DEVELOPMENT APPLICATION ASSESSMENT REPORT

Application Number:	DA2024/0939
----------------------------	-------------

Responsible Officer:	Megan Surtees
Land to be developed (Address):	Lot 29 DP 6195, 2 Orana Road MONA VALE NSW 2103
Proposed Development:	Construction of a dwelling house
Zoning:	R2 Low Density Residential
Development Permissible:	Yes
Existing Use Rights:	No
Consent Authority:	Northern Beaches Council
Land and Environment Court Action:	No
Applicant:	Metricon Homes Pty Ltd

Figure 1. Shadow diagram at 9am. Pink shadowing indicates shadowing from proposed development, and blue shadowing indicates extent of existing shadowing.

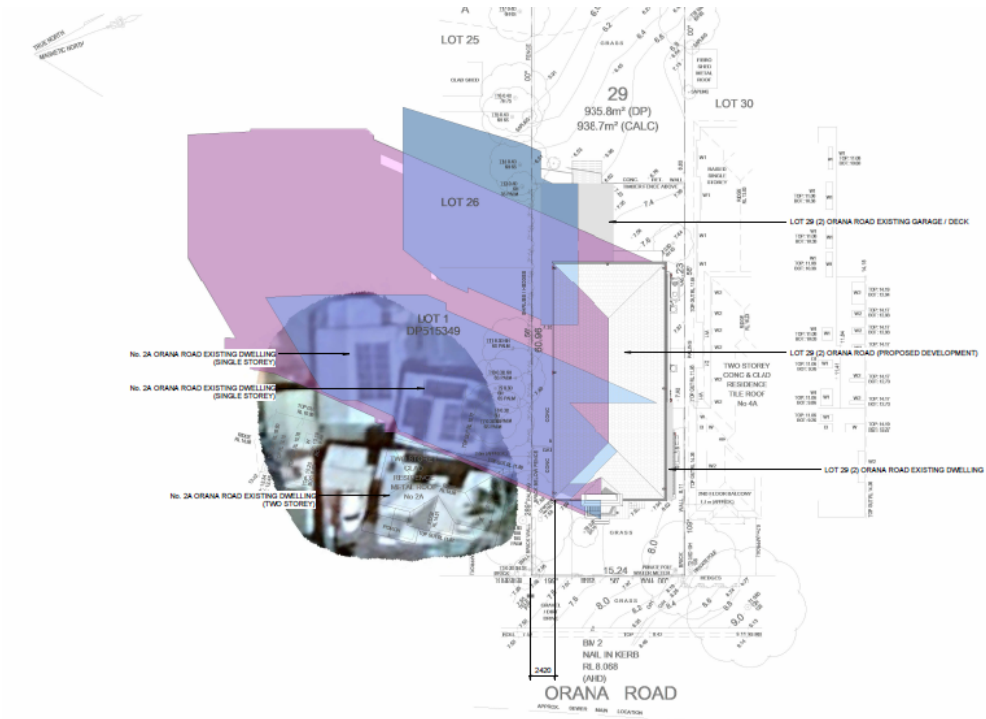
At 9am, the amended shadow diagrams show that the proposed development will overshadow the rear portion of the dwelling (including two thirds of the solar panels) and main private open space of 2A Orana Road, as well as the main private open space of other properties to the south, along Bassett Street. See figure below.

Figure 2. Shadow diagram at 12pm. Pink shading indicates shadowing from proposed development, and blue shading indicates extent of existing shadowing.

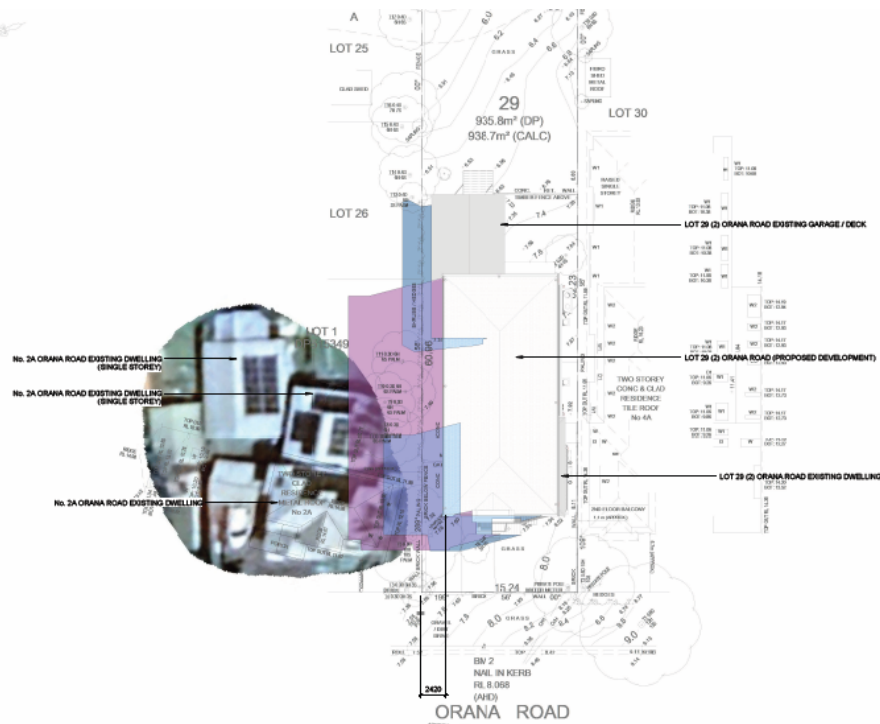
At 12pm, the amended shadow diagrams show that the proposed development will overshadow a portion of the northern area of the dwelling and private open space of 2A Orana Road. See figure below.

Figure 3. Shadow diagram at 3pm. Pink shading indicates shadowing from proposed development, and blue shading indicates extent of existing shadowing.

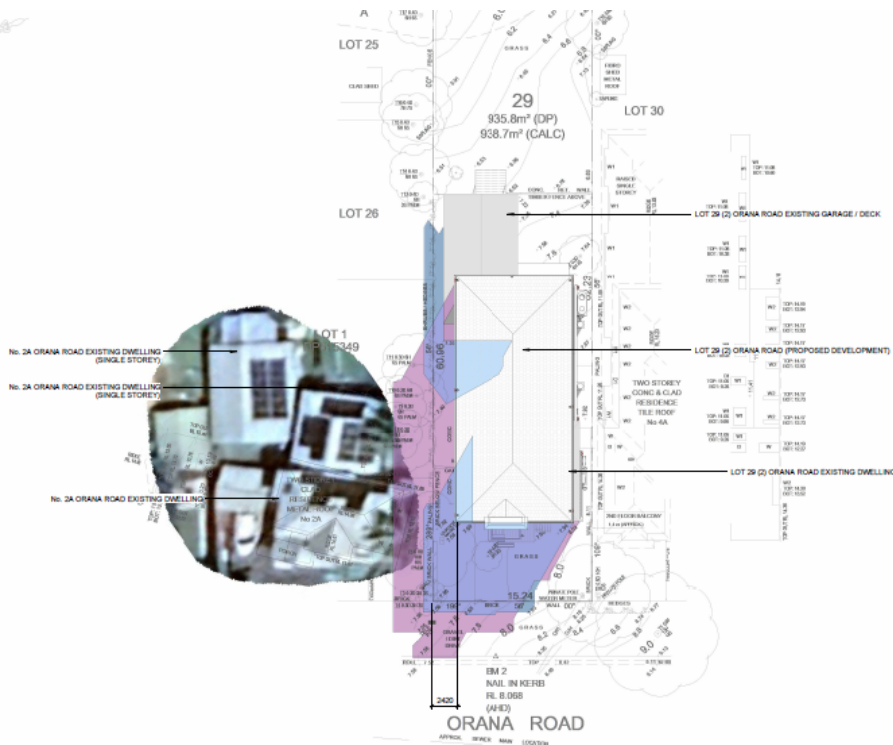
At 3pm, the amended shadow diagrams show that the proposed development will overshadow the northern area of 2A Orana Road. There is no overshadowing of the solar panels or main private open space of 2A Orana Road. See figure below.
